BEFORE THE ILLINOIS POLLUTION CONTROL BOARD

In the Matter of:)	
)	
)	
STANDARD FOR THE DISPOSAL OF)	
COAL COMBUSTION RESIDUALS)	PCB 2020-019
IN SURFACE IMPOUNDMENTS:)	(Rulemaking - Water)
PROPOSED NEW 35 ILL. ADMIN.)	
CODE 845)	
)	
)	
)

PRE-FILED TESTIMONY OF MARK HUTSON

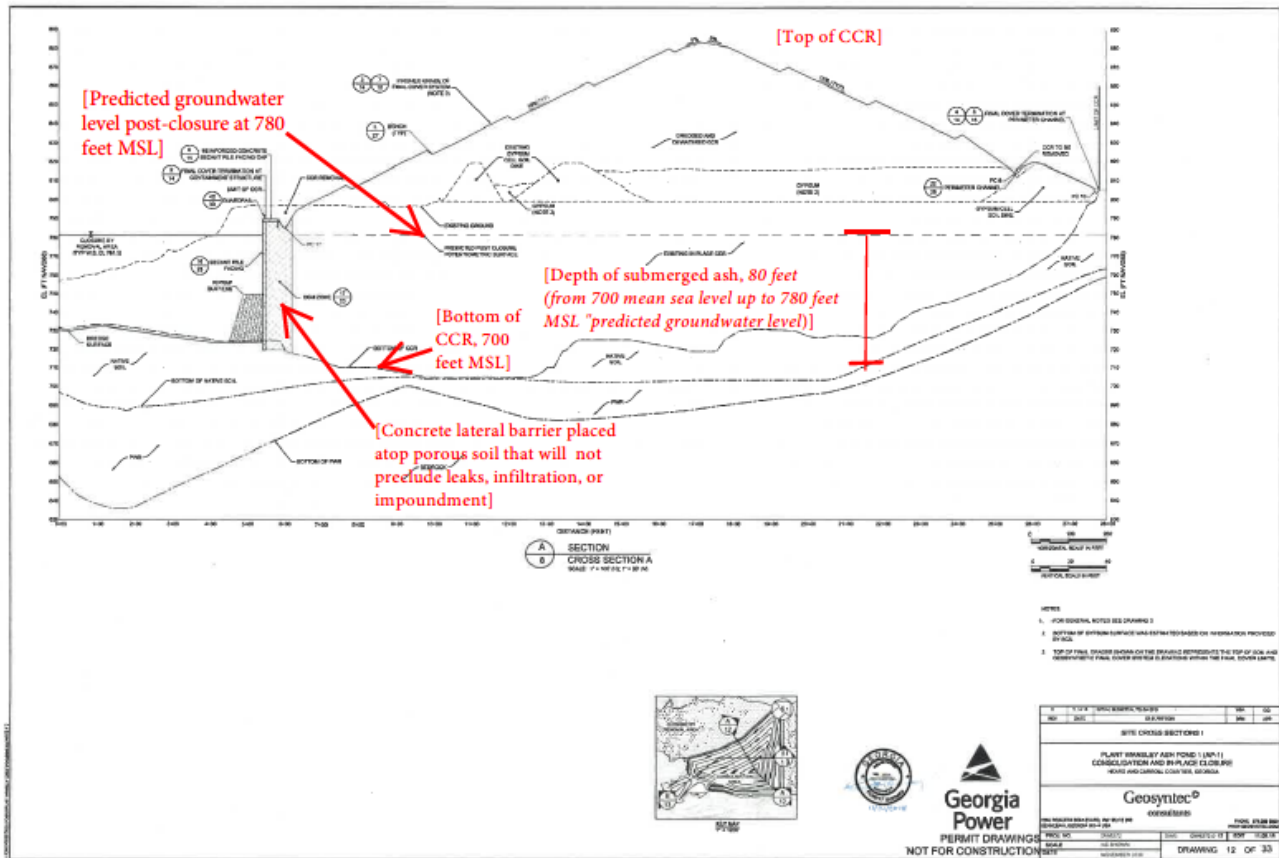
Without a clear and specific prohibition on leaving CCR in contact with groundwater, owner/operators are free to propose CCR unit closures that fail to contain CCR constituents in the closed CCR disposal unit. Utilities are essentially making the bet that migration of contaminants out of the disposal unit after closure will disperse and be sufficiently diluted such that additional remediation will not be required. Nationwide there are numerous examples of unlined CCR impoundments and landfills that have been constructed such that waste is either constantly or periodically saturated, where groundwater flows through waste. A particularly egregious example of a utility that is pushing the envelope of propriety is provided at Georgia Power's Plant Wansley.⁵

The overarching problem with Georgia Power's proposed Closure Plan is the basic truth that this plan would result in establishing a permanent waste disposal cell within, and over the deepest portions of, the existing impoundment; essentially creating a waste disposal cell within a surface water lake. This is, to my knowledge, an unprecedented closure proposal that upends common precepts of proper waste containment and permanent disposal, which allows the perpetuation of significant pollution rather than the remediation of it. An annotated cross-section through the proposed Consolidation Area and Closure by Removal Area is shown below.⁶

Figure 2. Stiff diagram showing ionic composition of samples of BAP background and downgradient groundwater and BAP water.

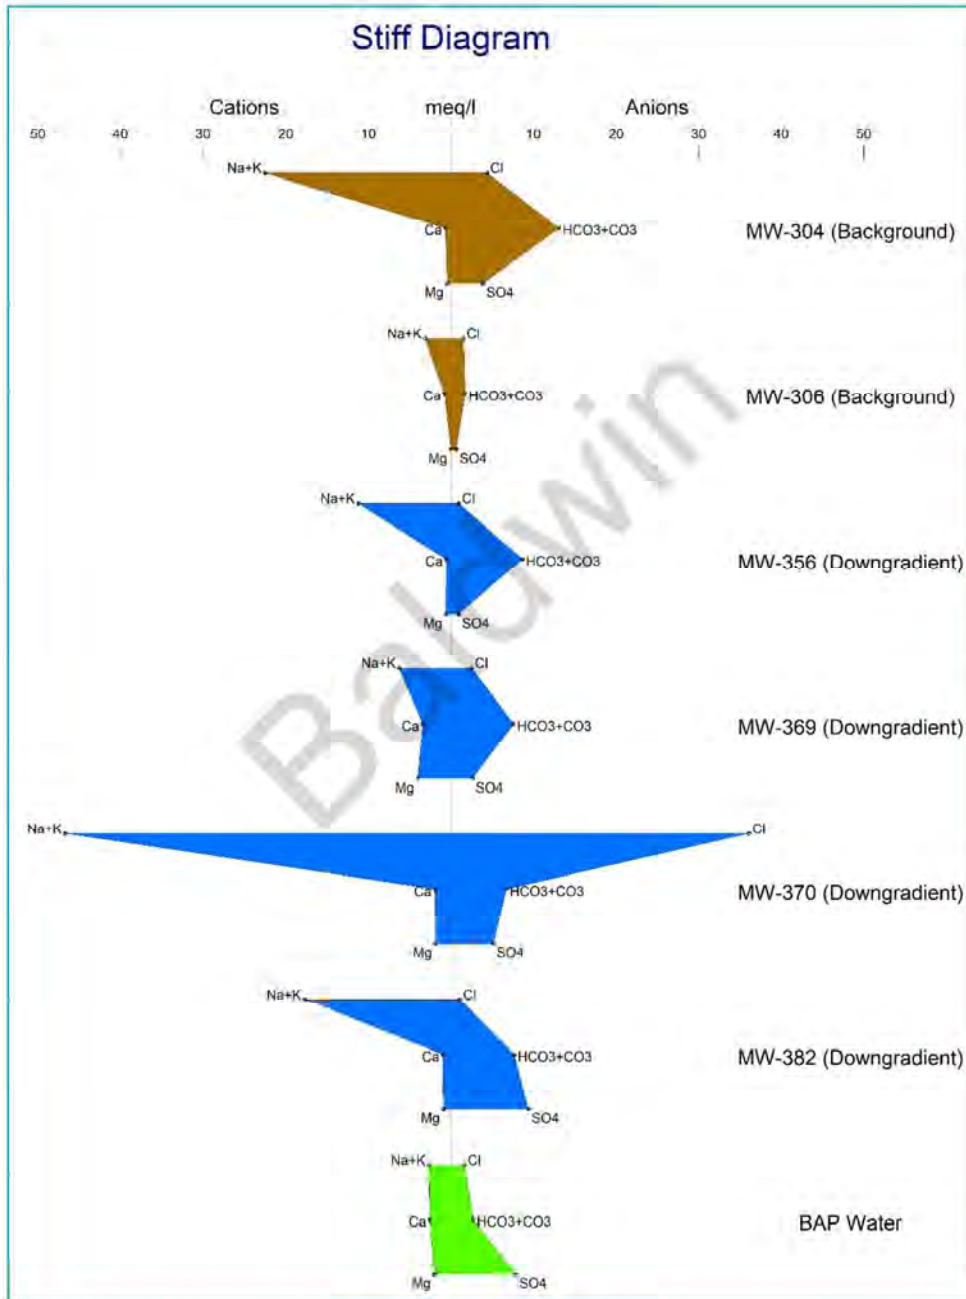
- The dominant cations in BAP groundwater at background and downgradient monitoring wells are sodium-potassium.
- Figure 2 indicates that MW-369 has a relatively higher proportion of calcium and magnesium cations than other wells in the groundwater monitoring system, although sodium-potassium cations are still dominant.

- The polygon associated with the BAP water sample in Figure 2 is relatively flat on the left side indicating there is no overly dominant cation.
- The dominant anions in most BAP monitoring wells are carbonate-bicarbonate, with the exceptions of downgradient monitoring well locations MW-370 and MW-382.

- MW-370 is the only location analyzed where the major anions are dominated by chloride, this results in a distinct polygon shape when compared to other sample locations as illustrated in Figure 2.

Figure 3. Stiff diagram showing ionic composition of samples of BAP background (brown) and downgradient (blue) groundwater and BAP porewater (green).

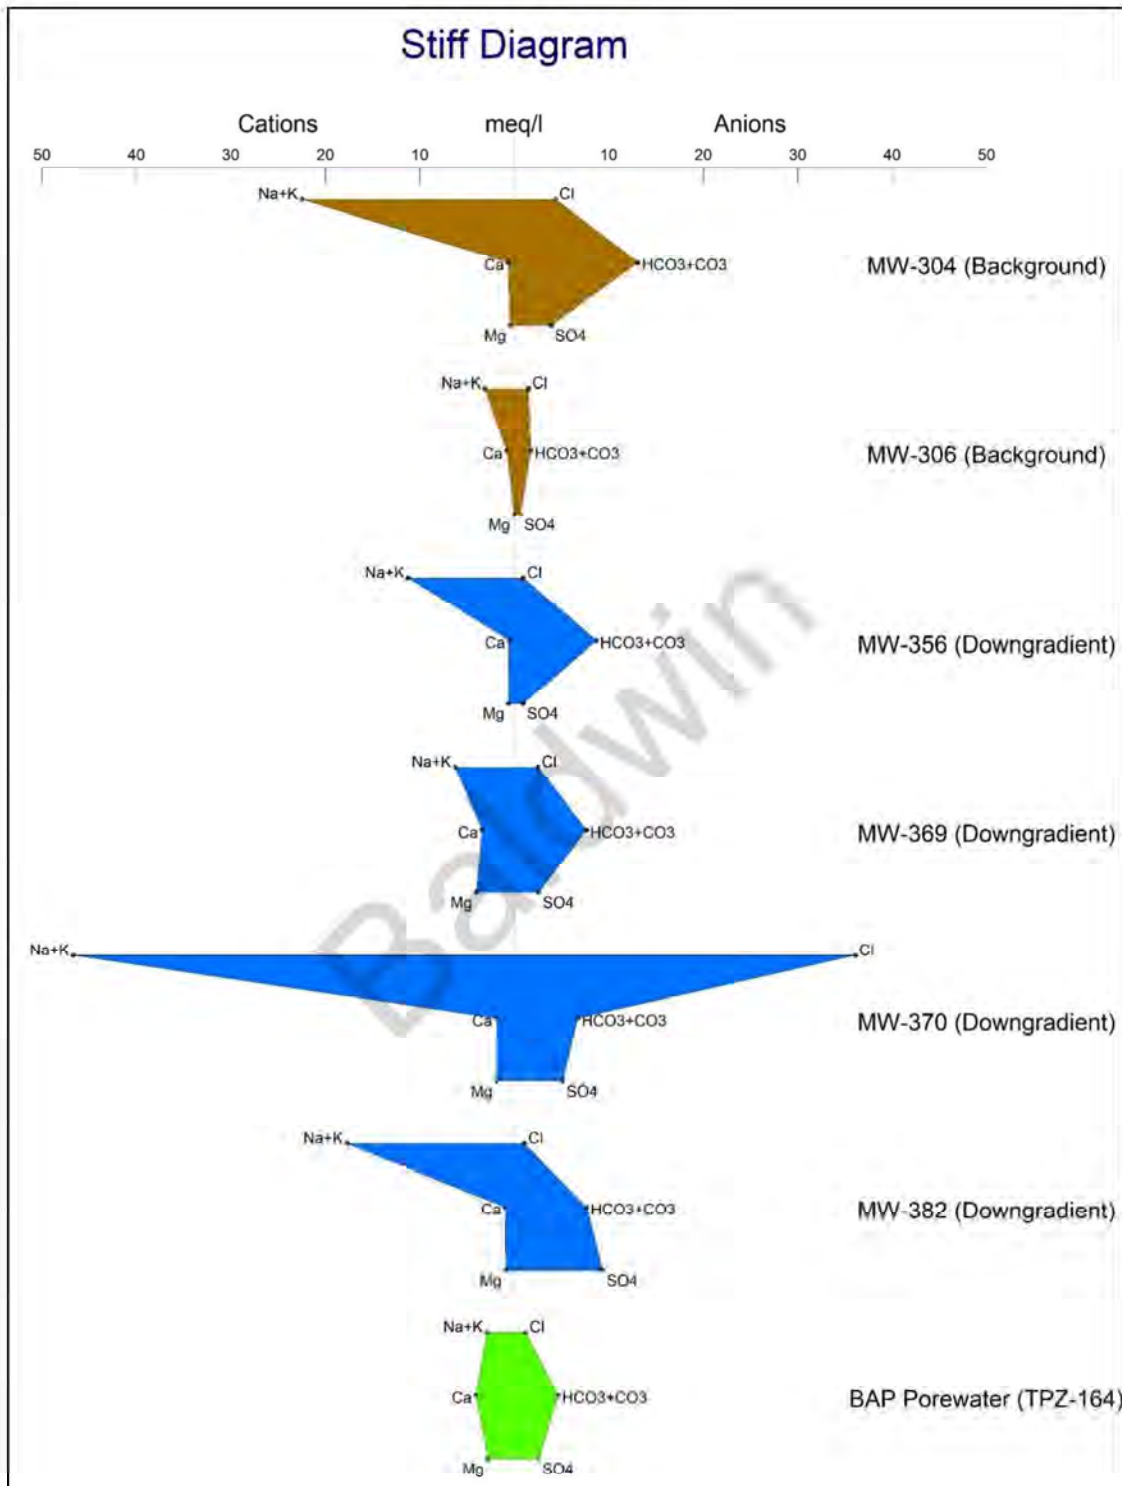
- The dominant anion at MW-382 is sulfate, however the concentration of carbonate-bicarbonate is consistent with the concentrations of carbonate-bicarbonate in other downgradient groundwater monitoring wells.

- The ionic composition of the BAP porewater is different than the ionic composition of the groundwater.
 - The dominant cation in the BAP porewater sample is calcium and the dominant anion is carbonate-bicarbonate. The resulting Stiff diagram is different in both shape and size from the groundwater diagrams.

The Stiff diagrams and analysis of ionic composition in groundwater and the BAP porewater sample indicate that the ionic composition of groundwater at MW-370 is not influenced by the BAP.
